Docket Item #8

**Development Special Use Permit #2011-0003 – James Bland
(Amendment to DSUP #2008-0013)**

Purpose of Application

Attachment #2 – Open Space Expansion

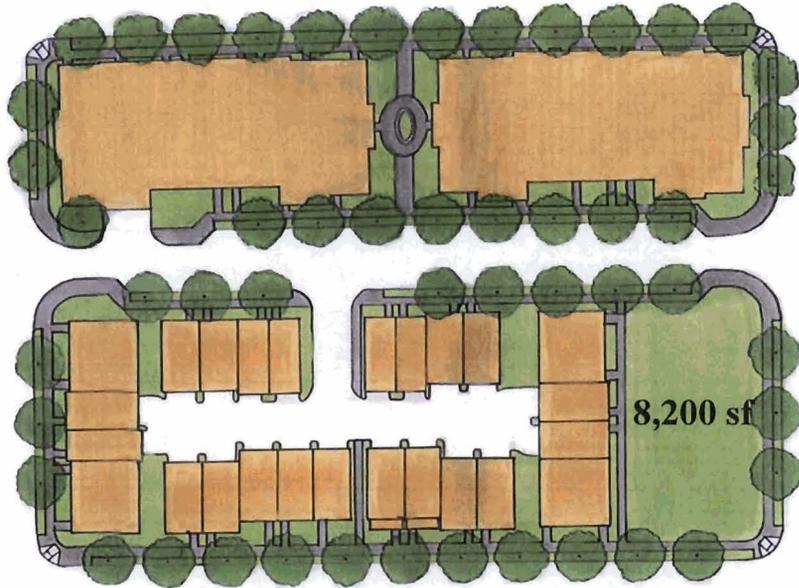
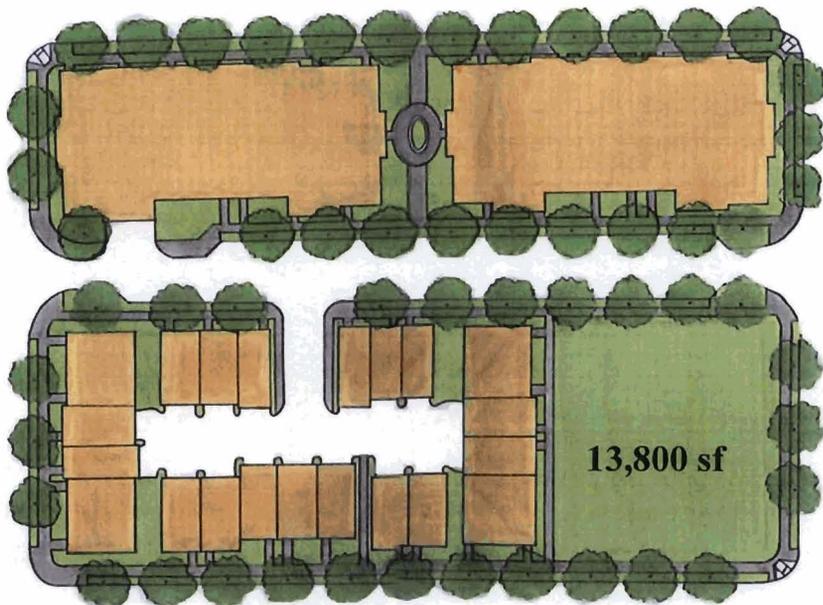
9. **[CONDITION AMENDED]** The applicant shall revise the site plan to eliminate 4 units in the southwestern block to provide a larger open space area at the corner of Montgomery Street and N. Alfred Street as generally depicted in *Attachment #2*. The park shall be subject to the following, to the satisfaction of the Directors of P&Z and RP&CA:

- b. In order to increase the size and viability of the proposed major park at the James Bland Redevelopment site, it is proposed that the City purchase from ARHA four market rate building lots adjacent to the planned open space at the southwest corner of Montgomery and Alfred Streets. This purchase of the four lots will increase the size of the park from about 8,200 square feet to approximately 13,000 square feet.
